MODULE CONNECTOR

It has been proposed that changes should be made to the barrel module connector. These changes come under 4 headings.

fig 4

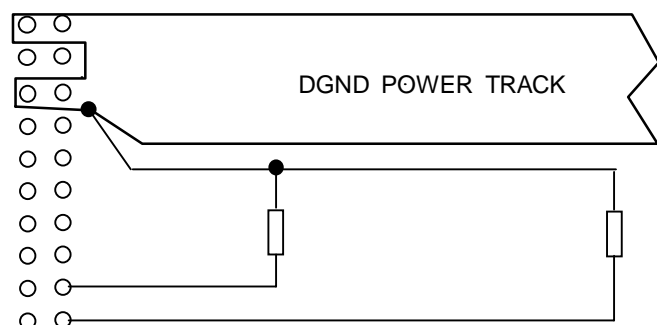
The current proposal is to use Thermistors. These have a higher temperature coefficient than Pt1Ks and a 2-wire readout can be used. The most straight-forward technique is to have the thermistors connected to DGND at the hybrid and to use 2 wires, temp1 and either temp2 or RESET as shown in fig 4, for the case where the sense lines are not taken to the hybrid. A return reference is required and DGND_sense can be used for this. However hybrid designers should note that the thermistors ought not be connected to DGND locally but close to the connector, as indicated by the sketch. In this case the error due to the voltage drop across the connector should be less than 2 mV

(there are 4 DGND pins, each less than 10 mOhms). For the proposed thermistors this corresponds to a fraction of 1 degree. Note that the sketch is purely symbolic in that it only indicates the principle, the actual pinout is not indicated.

fig 5

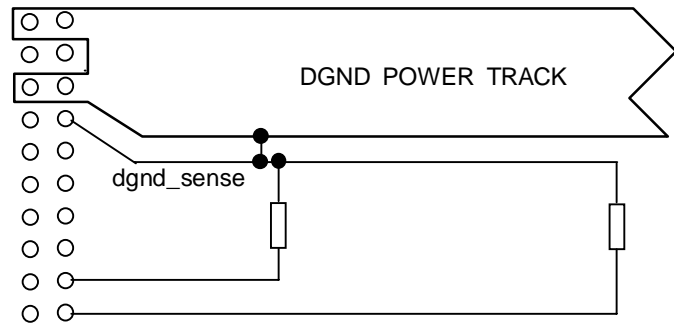
fig 5 shows the layout which should be used in the case where DGND_sense is brought onto the hybrid.
